SUBJECT: GENERIC LETTER 91-01 LICENSE AMENDMENT, HOPE CREEK GENERATING
STATION (TAC NO. M81927)

AMENDMENT TO FACILITY OPERATING LICENSE

Amendment No. 46
License No. NPF-57

SAFETY EVALUATION BY THE OFFICE OF NUCLEAR REACTOR REGULATION
RELATED TO AMENDMENT NO. 46 TO FACILITY OPERATING LICENSE NO. NPF-57
PUBLIC SERVICE ELECTRIC & GAS COMPANY
ATLANTIC CITY ELECTRIC COMPANY
HOPE CREEK GENERATING STATION
DOCKET NO. 50-354

Bases Figure B 3/4.4.6-1

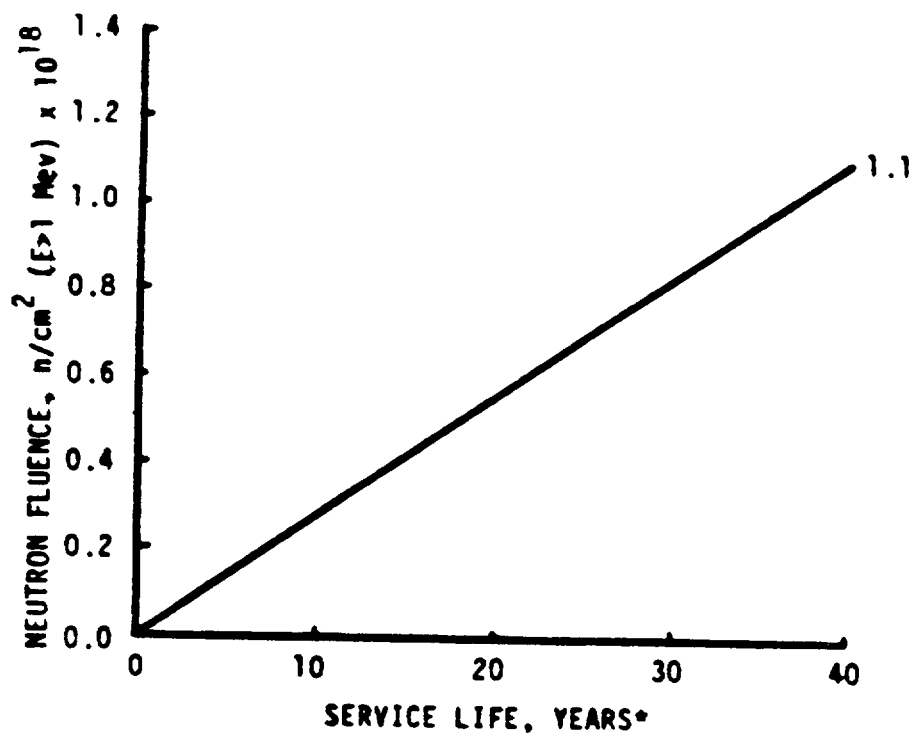
Additionally, the multiplier for the values of neutron fluence on the ordinate of Bases Figure B 3/4.4.6-1 is incorrect. Since the proposed change corrects an editorial error in the existing TS Bases, the change is purely administrative in nature and is acceptable.
